**Review of Landscape & Visual Impact  
Assessment by William James Landscape  
Architect (May 2021)**

**FLAT ROCKS WIND FARM**  
**REVIEW OF LANDSCAPE AND VISUAL ASSESSMENT**  
**BASED ON REVISED ZONE OF VISUAL INFLUENCE MAPPING**

Thursday, 13 May 2021

WILLIAM JAMES LANDSCAPE ARCHITECT

Figure 1: Original 2011 Turbine Layout

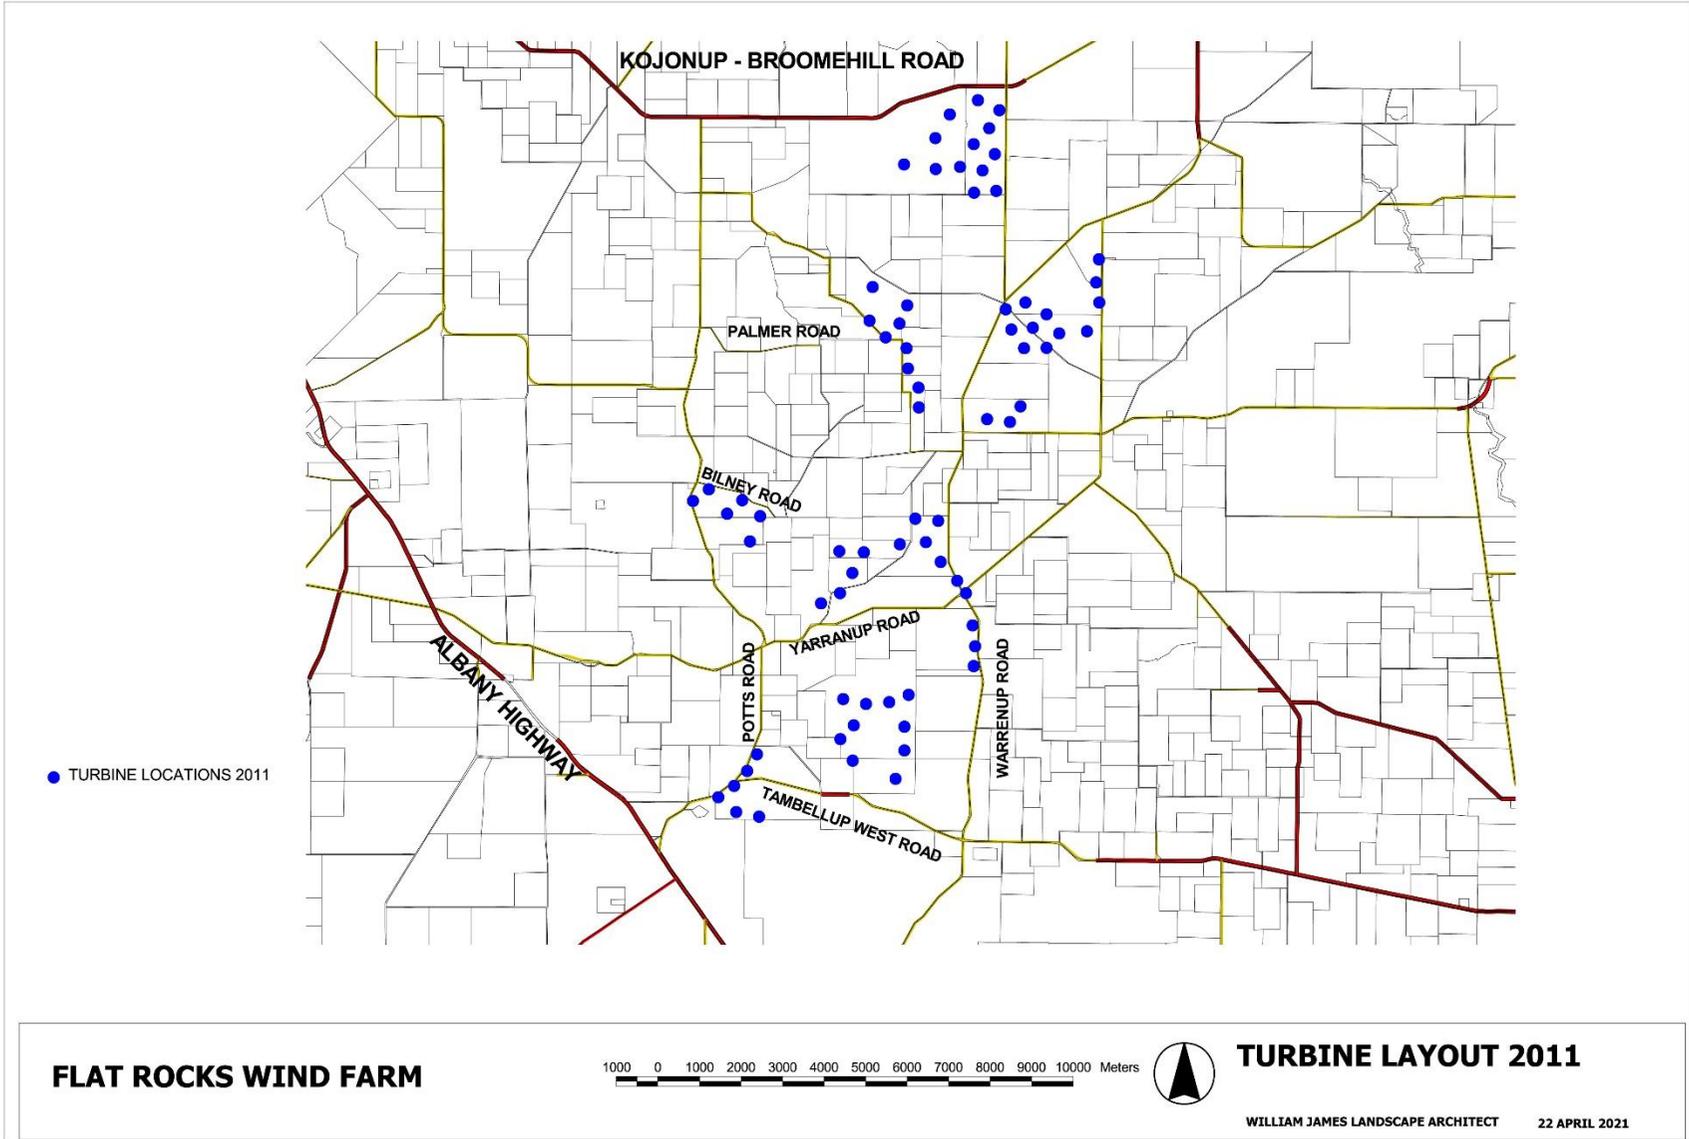
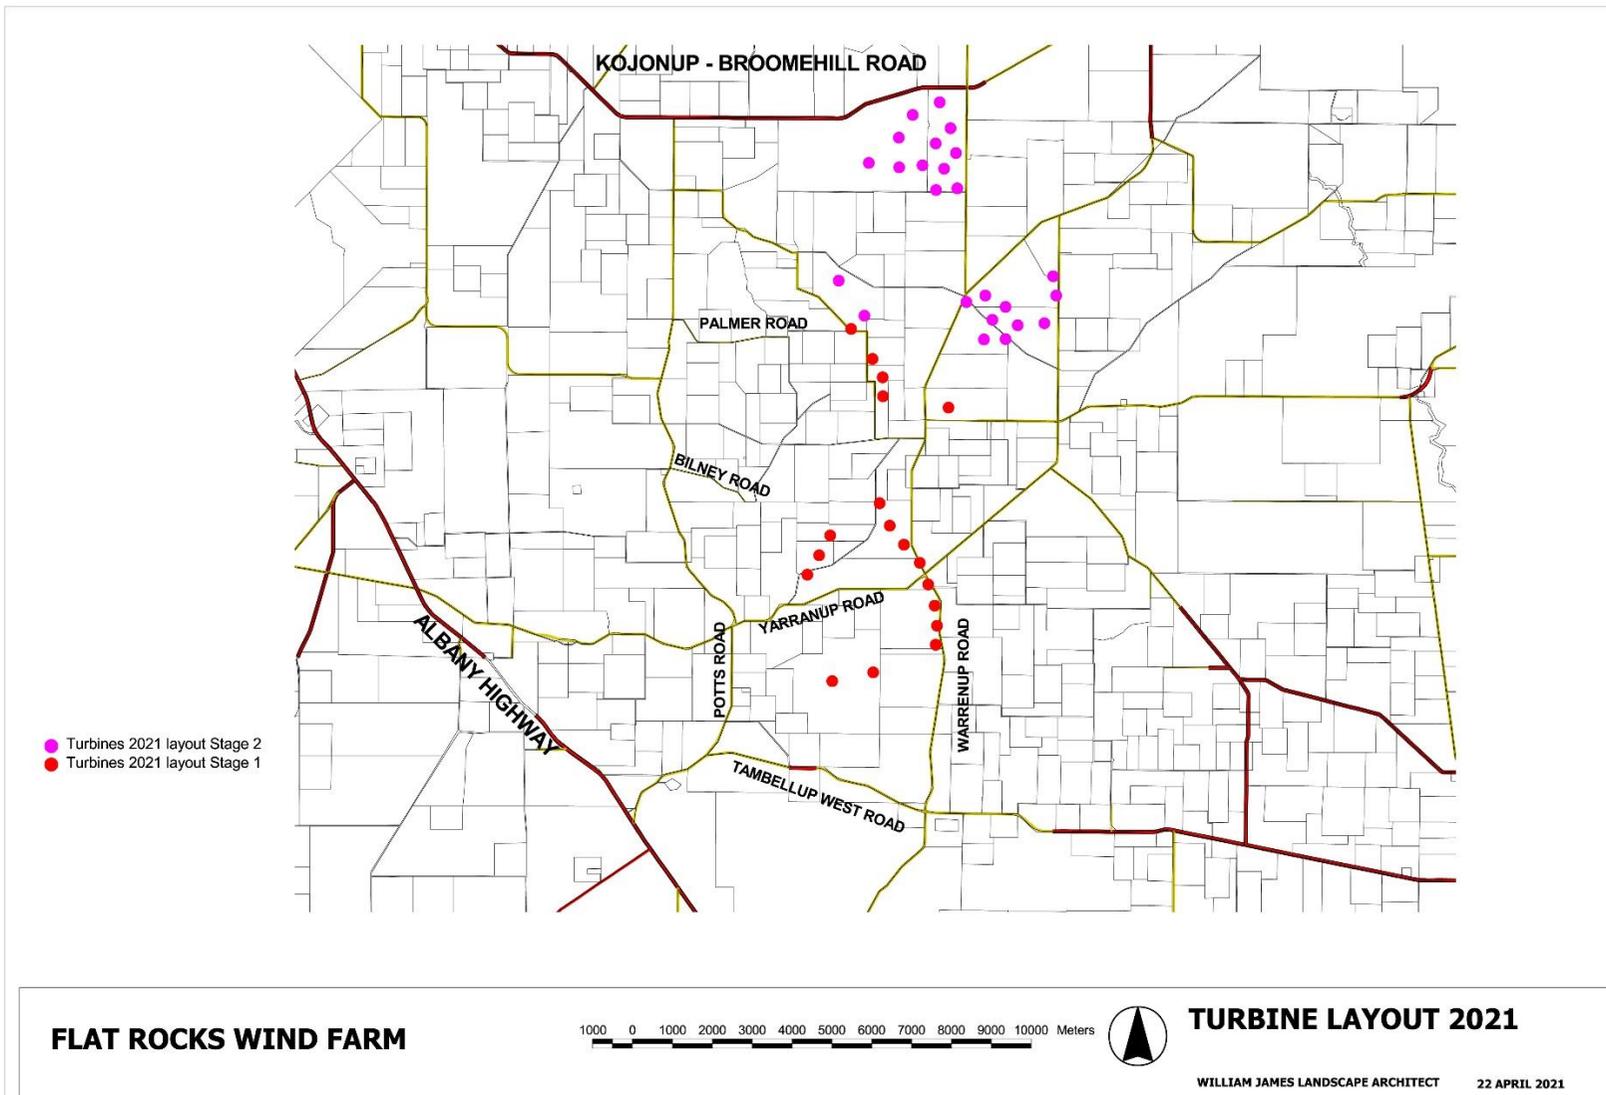
The proponent of the wind farm, a local consortium, Moonies Hill Energy Pty Ltd., asked the author to review the original Assessment to determine the change in visual impact resulting from a revised layout of wind turbines. The revised layout has come about due to the proposed substitution of the original turbines with fewer, but larger, turbines.

The original turbine towers were 84m high with 112m diameter blades, giving an overall height of 140m. There were 74 turbines. The proposed 2016 turbine towers were 117m high with a tip height of 180m. There were 41 turbines. The proposed 2021 turbine towers are 125m high with a height to the tip of the blades 200m. There are now 42 proposed turbines.

The original 2011 and revised 2021 turbine layouts are shown in Figure 1 and 2. Figure 3 is an illustrative comparison of the sizes of the three turbine options.

**Figure 4: Bar graph of numbers of hubs potentially visible in 2011 and 2021 layouts**

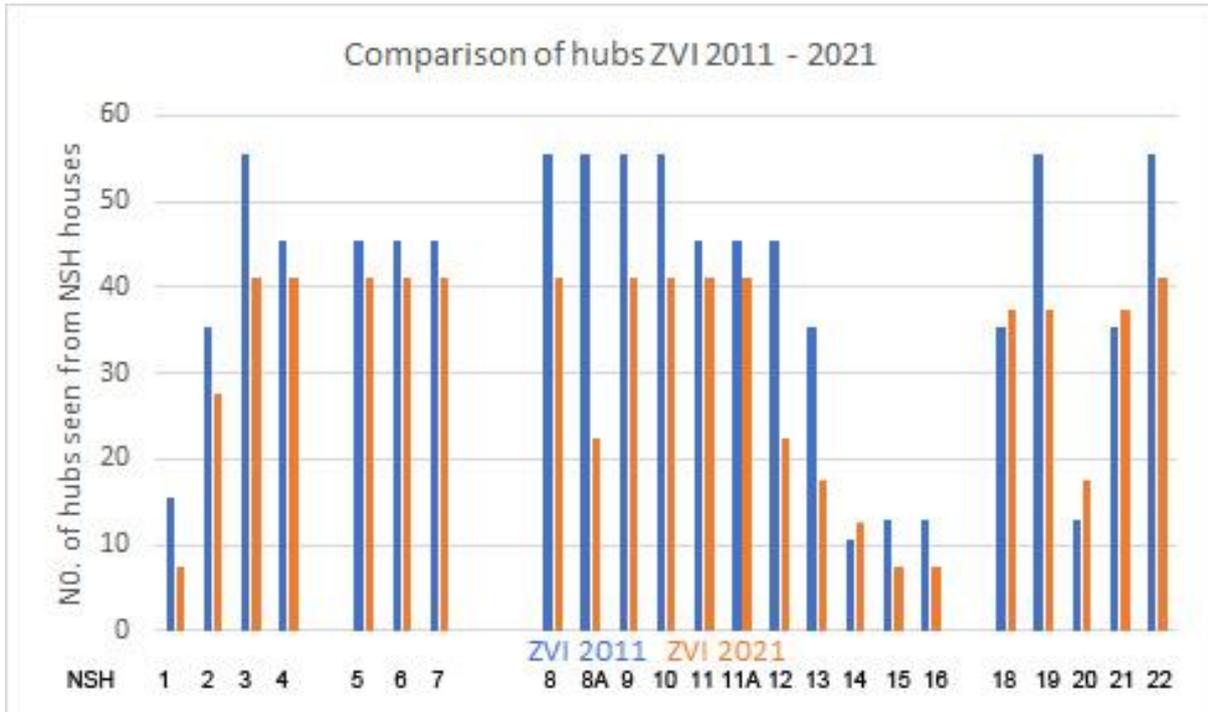
The comparison of the visual impact of the turbine hubs on non-stakeholder houses is as follows:

- 13 out of a total of 23 comparisons result in less hubs being visible in the 2021 layout than in the original 2011 layout.
- 6 out of 23 comparisons are less clear cut as the range of possible sightings has changed from the original 2011 ZVI mapping. On probabilities, however, it is likely that less will be visible in the 2021 layout.<sup>3</sup>

- One out of 23 comparisons would see more hubs<sup>4</sup> in the new layout.
- 3 out 23 non-stakeholder house would possibly see more hubs in the new layout<sup>5</sup>. Given that there will be fewer tips visible it is likely that the total impact on these houses will be the same for the original and the revised layouts. One house that may see more hubs is uninhabited.

- There are four new non-stakeholder houses identified in the 2021 ZVI mapping. As these were not included in the original assessment it is not possible to compare the impacts between the original and new layout.

The differing ranges between the two ZVI maps has been accommodated by averaging the ranges to arrive at figures that can be more readily compared. These averages are used in preparing the bar graphs that graphically compare the potential sightings.

**Figure 5 : Bar graph of number of tips potentially visible in 2011 and 2021 layouts**

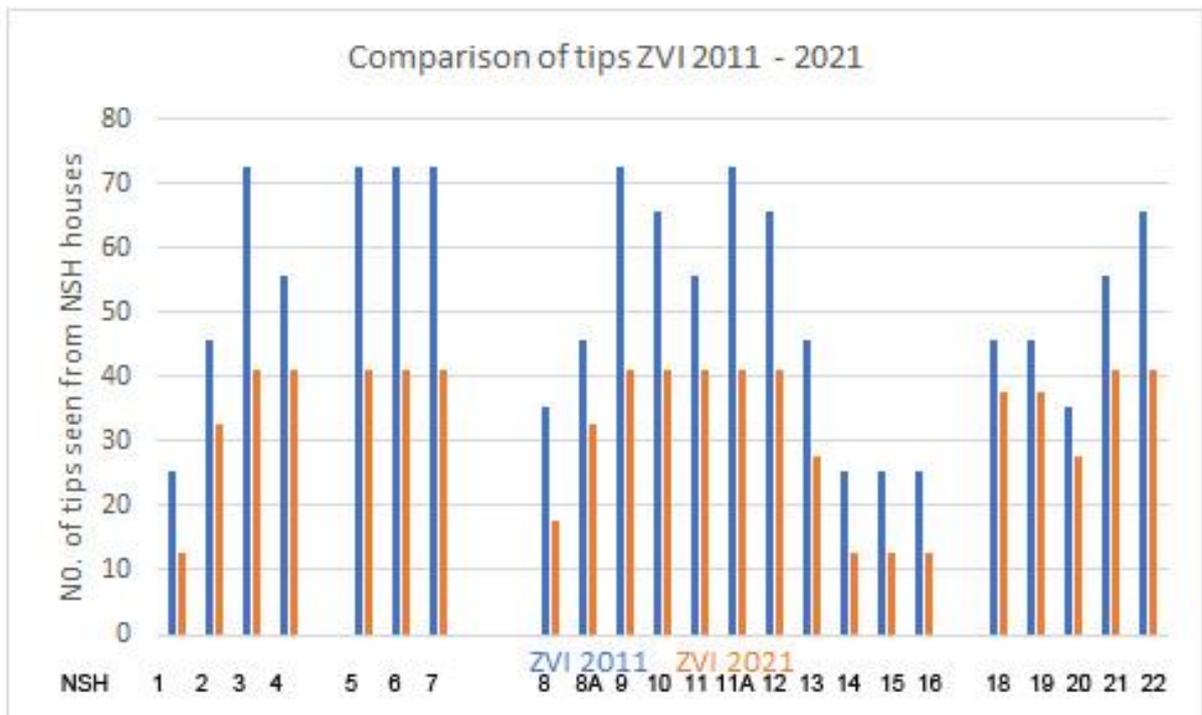
Table 1 indicates that all non-stakeholder houses will be less visually affected by the turbine tips in the new layout.

The above comparisons are derived from averaging within the range of hubs and tips seen in both layouts (e.g., if the range is 41-50 the value 45.5 is given).

The blank columns represent the non-stakeholder houses not mapped in 2011 but mapped in 2021.
